Interactive comment on “Multiscale soil moisture estimates using static and roving cosmic-ray soil moisture sensors” by David McJannet et al.

Review of the paper: “Multiscale soil moisture estimates using static and roving cosmic-ray soil moisture sensors” by: David McJannet GENERAL COMMENTS The paper describes a research project aimed at producing soil moisture estimates at a range of scales that are commensurate with model and satellite retrievals. The study involved static cosmic ray neutron sensors and rover surveys across both broad (36 km at 9 km resolution) and intensive (10 x 10 km at 1 km resolution) scales in a cropping district in the Mallee region of Victoria, Australia. Given the ever increasing lack of ground measurements, having medium-to-high resolution observations of soil moisture against which validating satellite soil moisture products is extremely important. With the advent of Sentinel 1 satellite sensor we will have soon soil moisture estimates at 1 km of reso-

Fig. 1. Intensive rover survey versus gravimetric soil moisture and AWRA_L model estimates

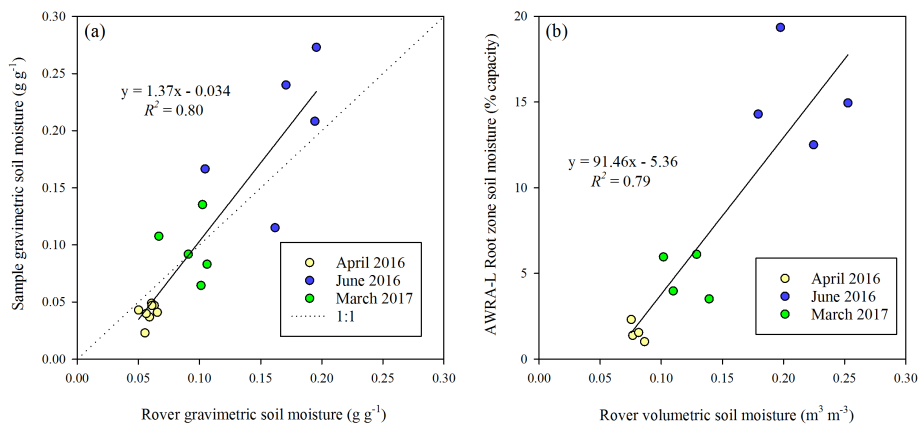
Page 7, Section 3.5 Intensive scale rover survey, Moderate, I think it is too much optimistic to say that the agreement is excellent based on only on two points and three times. Why not comparing spatially with model estimates? RESPONSE: We have now introduced two independent data sets to assess the rover performance and this has been a major change to the paper. These independent measures are distributed gravimetric point samples collected during each survey and estimates from the recently operationalised bureau of meteorology water balance model (5km resolution) estimates of root zone soil moisture. These two independent products are compared against both the intensive and broad scale results to demonstrate. Two new figures have been added results new text has been added to results and discussion sections.

RESPONSE: In response to the reviewer comments we have now made major changes and compared distributed gravimetric point samples from each survey to rover results for both the intensive and broad scale products. We have also compared rover survey results at intensive and broad scale against distributed point samples and 5 km resolution water balance model estimates of soil moisture. For this analysis we have used the recently operationalised Australian Bureau of Meteorology water balance model estimates of root zone soil moisture. We have added two new figures to this reposnse to show this comparison (see end of this submission)
